MODIFICATION APPLICATION ASSESSMENT

Application No:	D/2016/1529/C
Site:	1 Alfred Street, Sydney
Proposal:	<p>Section 4.55(2) modification of the approved development as follows:</p> <ul style="list-style-type: none">• Amendments to the approved hotel building to accommodate two additional hotel room levels with a revised façade design• Revisions to basement layout and footprint• Revision to ground floor retail layout• Rationalisation of building structure, services and plant, with amendments to typical floorplate• Revision to upper level bar and restaurant layout• Modification to conditions of consent
Background:	<p>On 11 May 2017, a deferred commencement approval was granted by the Central Sydney Planning Committee for demolition of all existing structures on the site and construction of a hotel (Tower B), including ground floor retail, 182 hotel rooms, and common hotel facilities. The approval also included excavation and construction of a six level basement for shared use by the hotel and the adjoining residential tower (Tower A), and public domain improvements and augmentation of physical infrastructure and utilities.</p> <p>The deferred commencement condition was satisfied on

Figure 4: Diagrammatic view of Levels 23-25 as approved (left) and proposed to be modified (right).

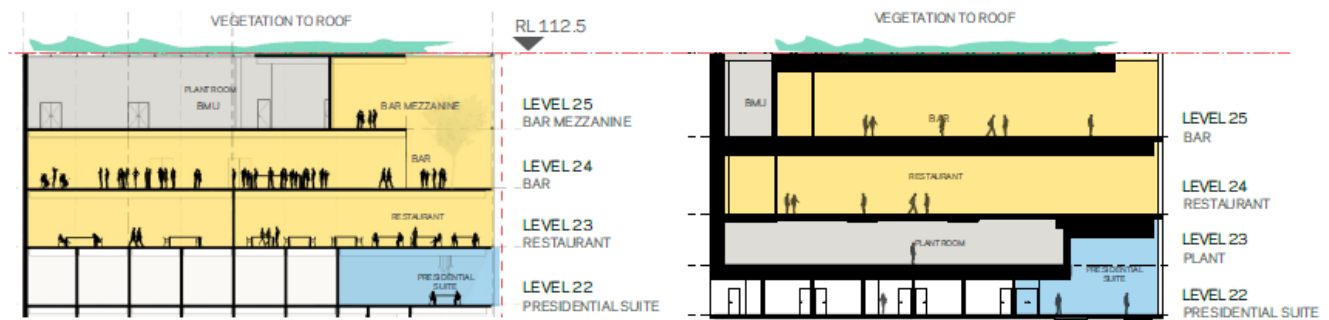
Applicant's Submission: The applicant has reviewed and revised the hotel design with changes to the lift core, decreased back of house, reduced plant areas, reduced structural transfer floors, reduced floor to floor heights (not floor to ceiling heights), and ground floor and basement reconfigurations. Partnered with these structural changes, design changes include:

- Increase in ground floor retail spaces with additional activation to Rugby Place and Crane Lane, with secondary access to the hotel lobby from Crane Lane;
- A larger Level 25 bar space (with karaoke area deleted) and double height presidential suite;
- Level 2 Ballroom space redesigned as multifunctional spaces with flexible partition wall system;
- Typical hotel room increase in size from 36sqm to 38sqm;
- Amendment to the 'pixel' façade to "enhance the visual legibility of a gradual blend and transition between the podium form and the tower."¹ An intermediate 150mm pixel depth is introduced to blend between the 300mm pixel depth;

Assessment: The amendment has merit and is supported. The revised design maintains the important features of both the design competition winning scheme and the approved development, including the 'pixel' façade design. The building remains within the approved Stage 1 building envelope, the approved GFA and approved height. The revised ground floor design provides additional activation to the laneway network with additional retail tenancies and hotel entry points. The internal changes to the hotel are acceptable.
